**Planning Act 2008 and The Infrastructure Planning (Examination Procedure) Rules 2010  
Highways England's Application for a Development Consent Order for the A303 between  
Amesbury and Berwick Down.**

## **A303 AMESBURY TO BERWICK DOWN DCO APPLICATION (TR10025)**

### **Representations of the Council for British Archaeology**

Figure 1 The Wilsford shaft and claimed 'sinkholes'

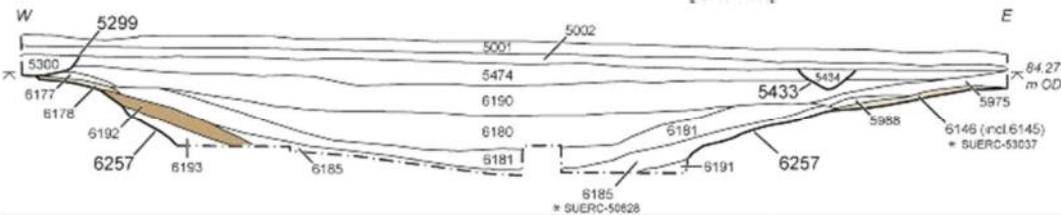
They express unshakeable faith in the identification of large pit-like features as 'sinkholes' from excavations that only investigated the uppermost ('tertiary') fill. These large pit-like holes or shafts exhibit characteristics similar to the more familiar natural processes of how large ditches that are left open change profile and infill as the sides erode and create primary and secondary fills by natural erosion/deposition process by which all but the very bottom profile is the product natural rather than human action. The Wilsford shaft (see Fig 1) is an extreme example where the unquestionable evidence of human creation in the form of bronze axe and antler pick marks only survived in the un-weathered lowest section below 12m down.

The character of the largely natural processes of initial collapse of sides and primary and secondary infill depends very substantially on the nature of the initial shape of the hole as created by natural chemical and water solution, natural collapse, or human excavation; the character, stability and erodibility of the substrate into which the hole is sunk; the depth and diameter of the void; how long the hole is kept open by natural or human agency; the relative stability and erodibility of substrate, subsoil and topsoil relative to speed of erosion and infill; any human intervention to recut or reshape the hole.

Figure 2: Alignment of base of dry valley relative to N arc of ‘Massive Pit Structure’.

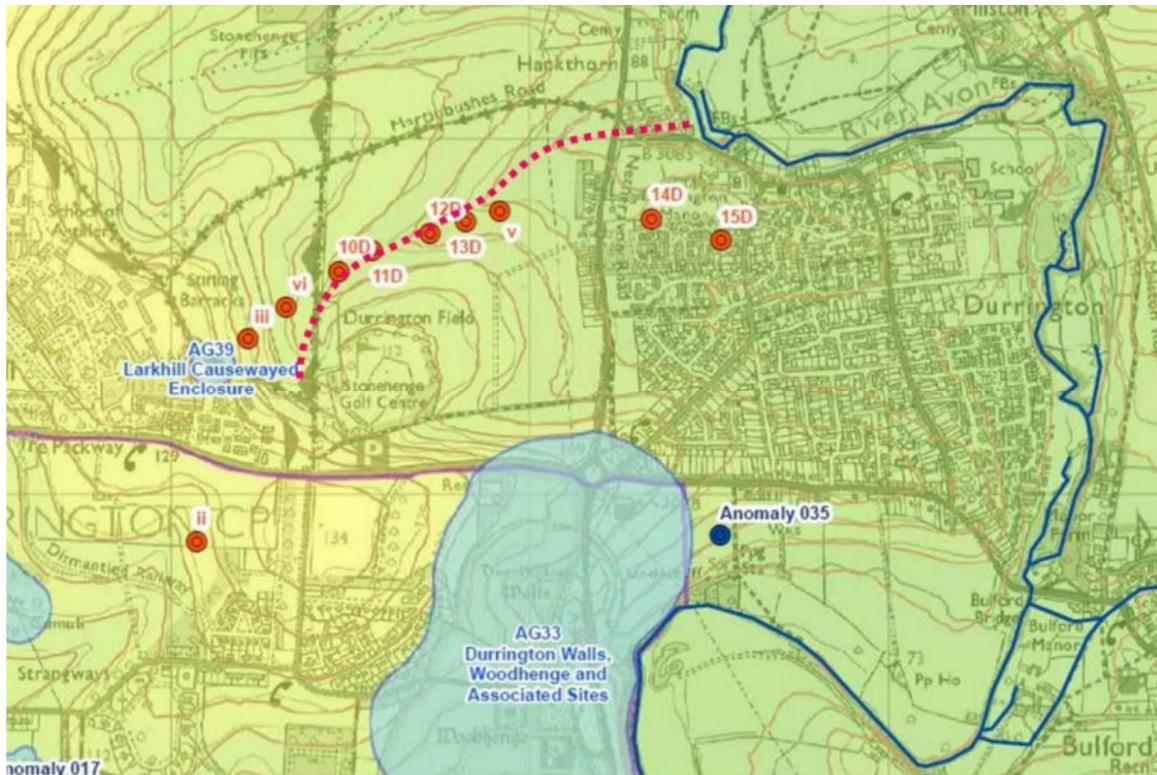
Taken as a whole, the majority of the features forming the N arc are NOT on the floor of the dry valley, and its alignment is clearly askew to the line of the dry valley (see Figure 2 below). Furthermore, since the alignments cross and have similar curvatures it is more or less inevitable that a small number of the anomalies would roughly follow its base – in fact only one is on its centre line<sup>6</sup>

*“Unlike the northern series of sinkholes/dolines which are located along a dry valley to the north of Durrington Walls, the 2020 SHLP paper suggests that the ‘southern arc’ appears to disregard dry valleys, which occur between Anomalies 7A and 8A, and between 2A and (i), and crosses slight ridges.”*

**The HIA Addendum** also seeks to convey the misleading impression that the whole of the N arc follows the bottom of a dry valley and that somehow reinforces their being of natural rather than anthropogenic origin. Para 2.9.2 quotes Hopson et al 2006<sup>7</sup> p 214, that *“Dissolution is enhanced where underground drainage routes are concentrated such as along valley floors and at spring lines”* But this is the only comment relating to valleys (dry or not), and this follows a main introductory statement that –

Fig 3: Geophysical anomaly 11018; Possible ferrous

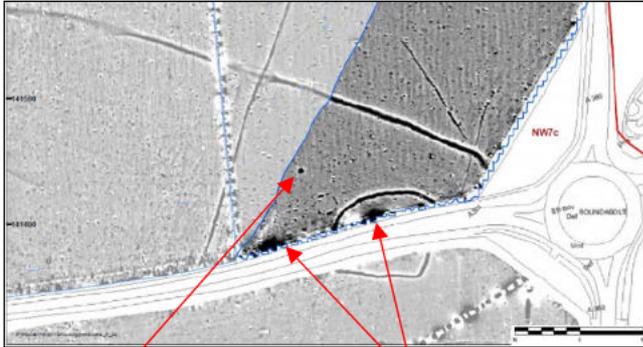
In the case of 'Anomaly 34' the location is assumed to be immediately adjacent to the road, interpreted in the original geophysical report as ferrous. But at the scale of fig. 9 this is also not far from anomaly 11018 described at para 4.2.32 as

*“Approximately 22 m to the north-west of the **11017**, there is a moderately positive circular anomaly (**11018**). This is 5 m in diameter and surrounded by a weakly negative response on the outer edge. This is most likely associated with a large pit-like feature of uncertain date. The proximity to the rounded enclosure at **11016**, may suggest it is associated with contemporary settlement activity.”*

Also unnumbered, a ‘Tumulus’ is marked on the base map for the HIA Figure 6C depicting undesignated features, which also shows a blue blob at this location. The closest numbered features shown on ES Fig 6.8 to this location is No. 2004, but the Gazetteer entry for that is described as being east of the A360, not west.
